REVISION TO PUB'S STANDARD DRAWING – MANHOLE ON SLOPE (REVISED DRAWING NO.: PUB/WRN/STD/011)

Annex A – Key Changes to PUB/WRN/STD/011A

WRN_STD_011A.pdf

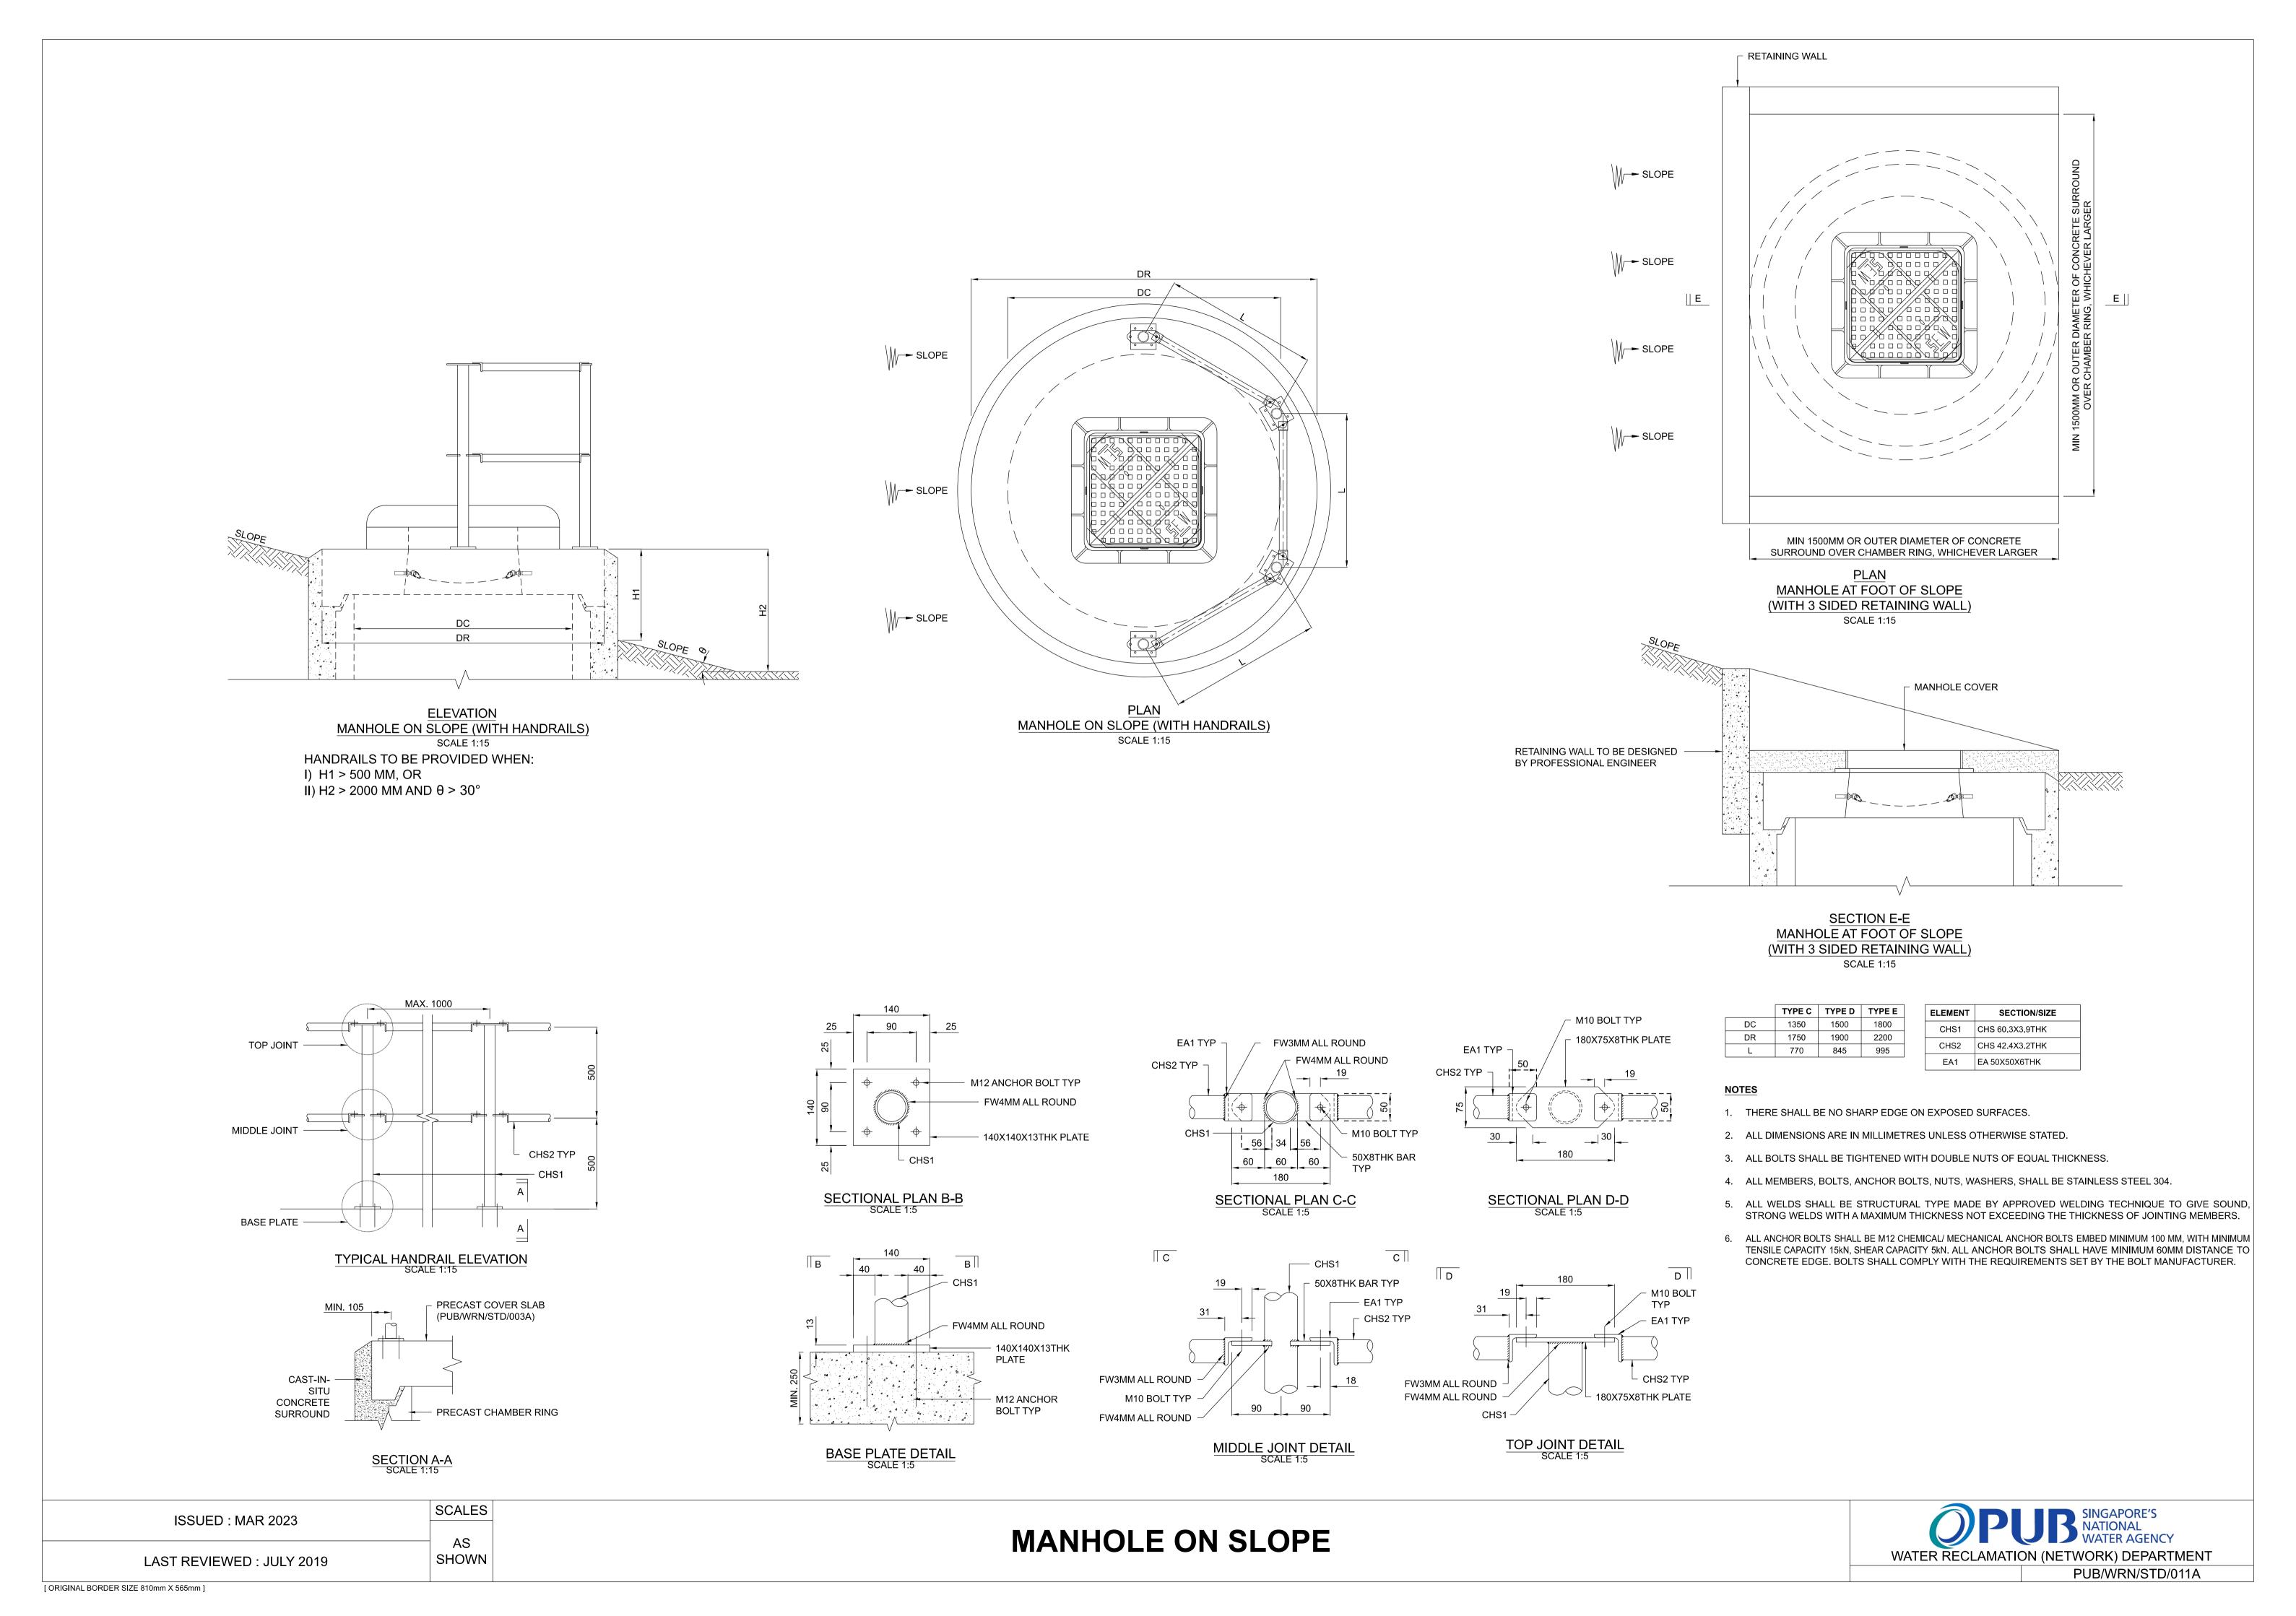
PUB has enhanced the standard drawing for the design of manholes constructed on slopes with consideration for safety. The revised standard drawing (**Drawing No.: PUB/WRN/STD/011A**) is attached below and can also be downloaded at the hyperlink: https://www.pub.gov.sg/compliance/industry/drawings. Key changes to the said standard drawing are stated in **Annex A**.

S/N	Descriptions
1	The material for handrails, including all members, bolts, anchor bolts, nuts, washers, etc., shall be of stainless steel 304.
2	 Handrails are to be provided when: the exposed wall of the side of the manhole to the downhill slope exceeds 0.5m in height or; the height from the manhole cover slab to the flat ground exceeds 2m and the angle of slope is more than 30 degrees.
3	The height of handrails is standardised to 1m.
4	Handrails span and elements dimensions are revised.
5	The safety chain requirement for handrails is removed.
6	The minimum internal diameter of manhole on a slope shall be 1350mm.
7	All anchor bolts shall be M12, installed mechanically or chemically, with minimum embedment depth of 100mm. The minimum tensile capacity and shear capacity of anchor bolts shall be 15kN and 5kN respectively.
8	All anchor bolts shall have a minimum distance of 60mm to the concrete edge of manhole cover slab.

9	The base plate has been revised from a round to a square shape.
10	The handrail grab bars and post connection are changed to bolted joint.

- 2 All new Development Control (DC) submissions shall adopt the revised drawing (Drawing No: PUB/WRN/STD/011A) and comply with the new design requirements from 1 Sep 2023 onwards. During this transition period, we encourage all industry professionals to adopt the revised drawing and the new design requirements early where this is possible.
- If you have any further queries regarding the revised standard drawing, you may contact Assistant Director Mr Lee Jia Yi at lee jia yi@pub.gov.sg or email to pub one@pub.gov.sg.
